#2019-160
Bohl Farm Final PUD Amendment – Five Below Outlot
Project Review for Planning and Zoning Commission

Meeting Date: October 16, 2019

Request: Final Planned Unit Development Amendment to allow exterior changes to the building façade and signage including an additional variation for increased wall signage.

Location: 5500 Northwest Highway

PRELIMINARY LANDSCAPE PLAN
FREDDY'S FROZEN CUSTARD
5500 NORTHWEST HIGHWAY, CRYSTAL LAKE, IL

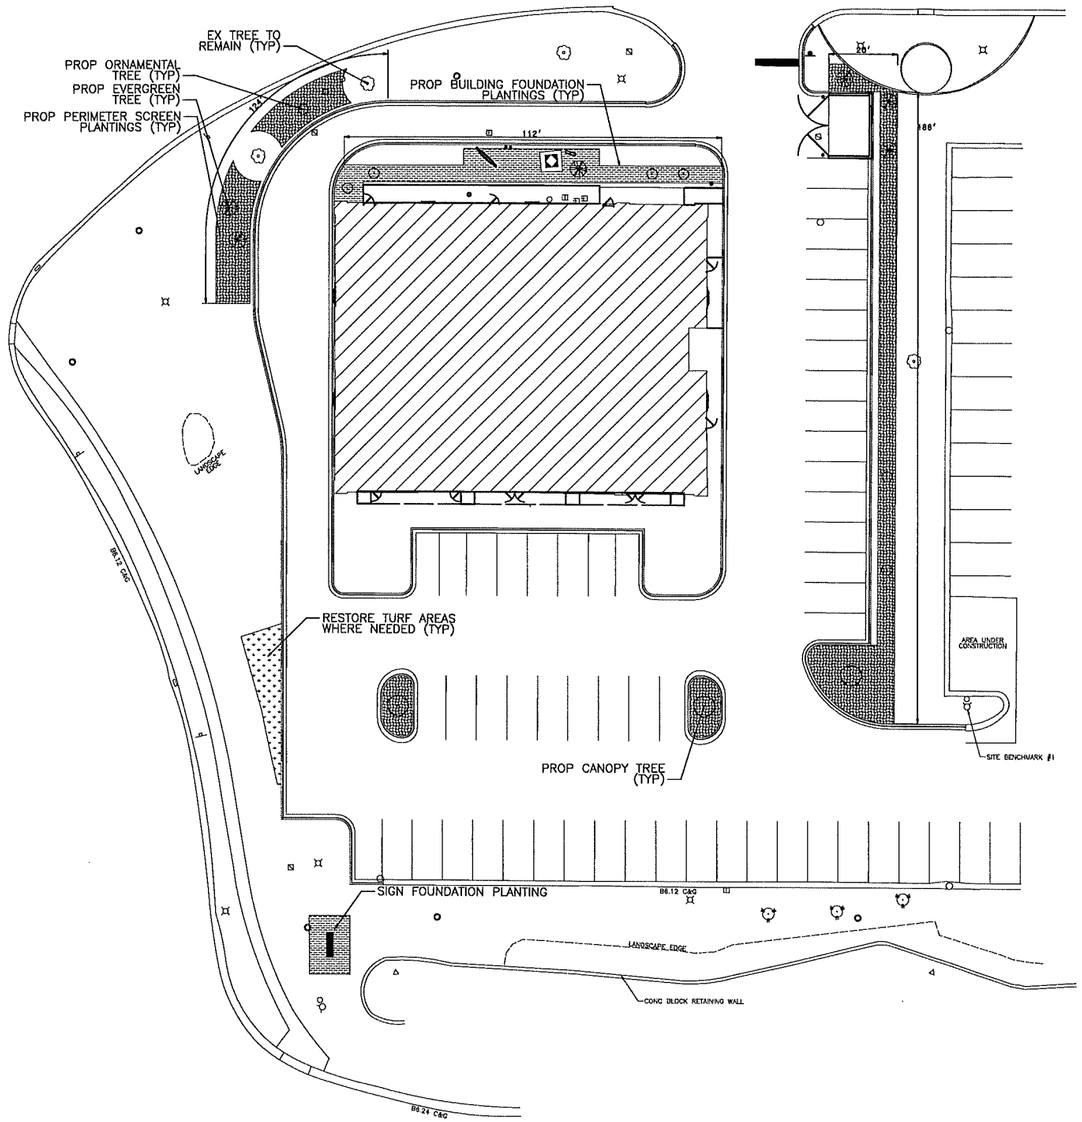
4. Landscape Plan
   A. Provide landscape material, to be reviewed and approved by staff, for the east elevation, to break up the blank façade.

SHEET:
A2.0

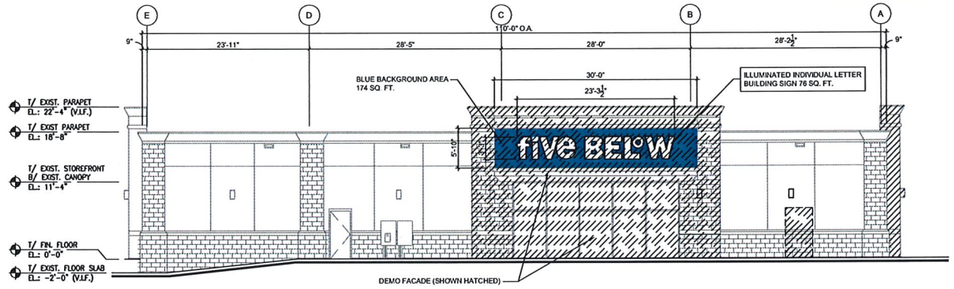
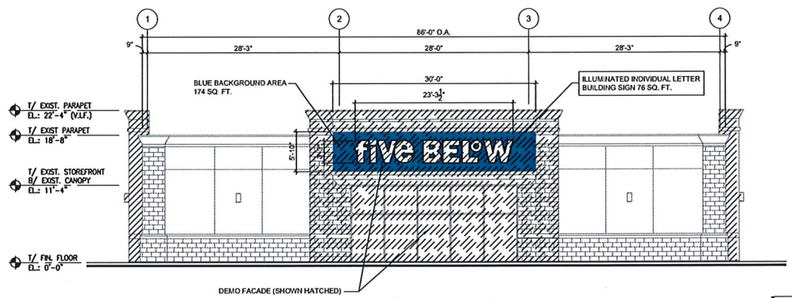
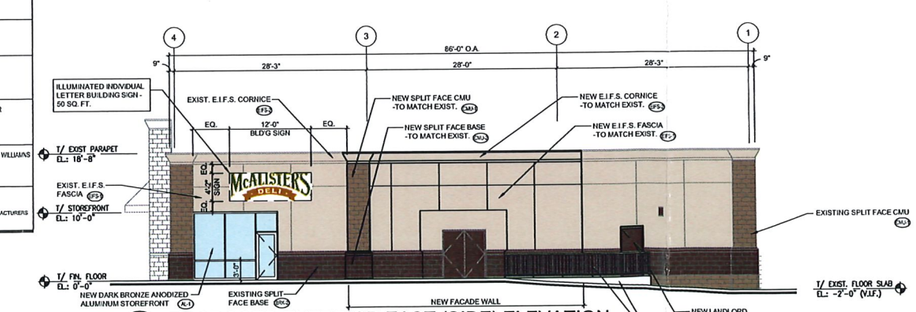
3. Architectural Elevations
   A. Add in the knee wall across the front of the glass façade except at door locations.
   B. For the front elevated entrance feature, provide a return of at least 3 feet, to eliminate the "Texas town" style element.
   C. Provide awnings on the rear elevation over the two other tenant spaces.

D/F INT. LED ILLUMINATED DISPLAY

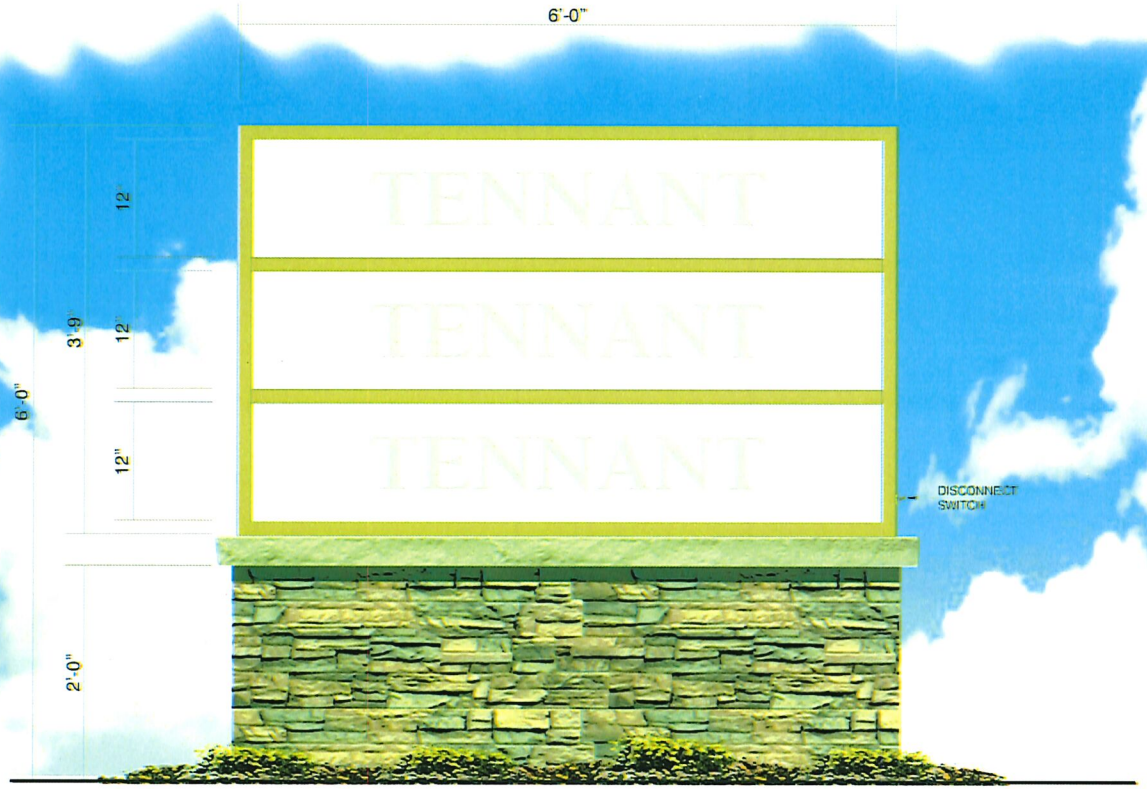
5. Provide a cornice top element on the proposed monument sign, to match the other freestanding signage in the development.
